- Subject** ▶ Change of Ball Bearing
- For Models** ▶ 5620D, 5621D, 5621RD, 5630D, DK1016, DK1021, DK1022, LS711D, LS800D
(DK1061 and DK1021 are cordless tool kits that include 5620D. DK1022 is a cordless tool kit that includes 5630D.)
- Country** ▶ All countries
- Description** ▶ For standardization, Ball Bearings have been changed as described below.

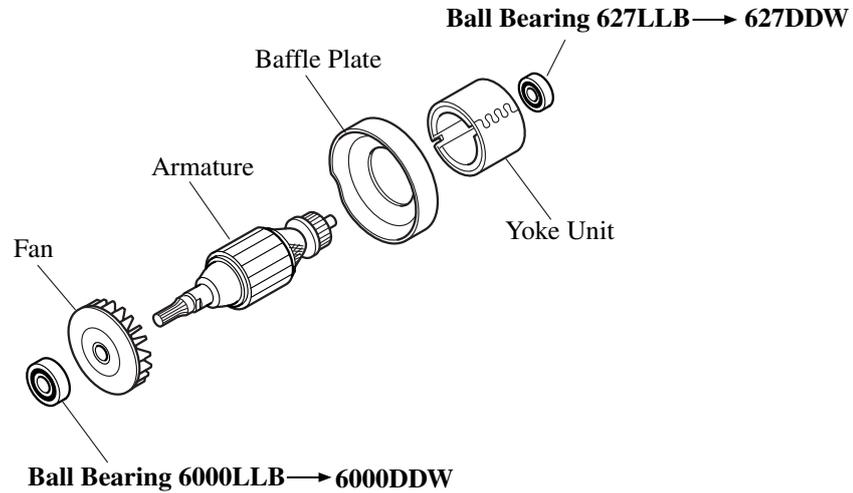
▶ Current	▶ New
Ball Bearing on Fan side	Type	6000LLB	6000DDW
	Part No.	211061-7	211088-7
Ball Bearing on Commutator side	Type	627LLB	627DDW
	Part No.	210025-8	210023-2

Item No.	Current part	Q'ty	I/C	New part	Q'ty	Note
5620DW:035 5621RDW:034 5630DW:026 LS711DW:028 LS800DW:028	Ball Bearing 6000LLB 211061-7	1	Yes	Ball Bearing 6000DDW 211088-7	1	
5620DW:031 5621RDW:038 5630DW:022 LS711DW:022 LS800DW:022	Ball Bearing 627LLB 210025-8	1	Yes	Ball Bearing 627DDW 210023-2	1
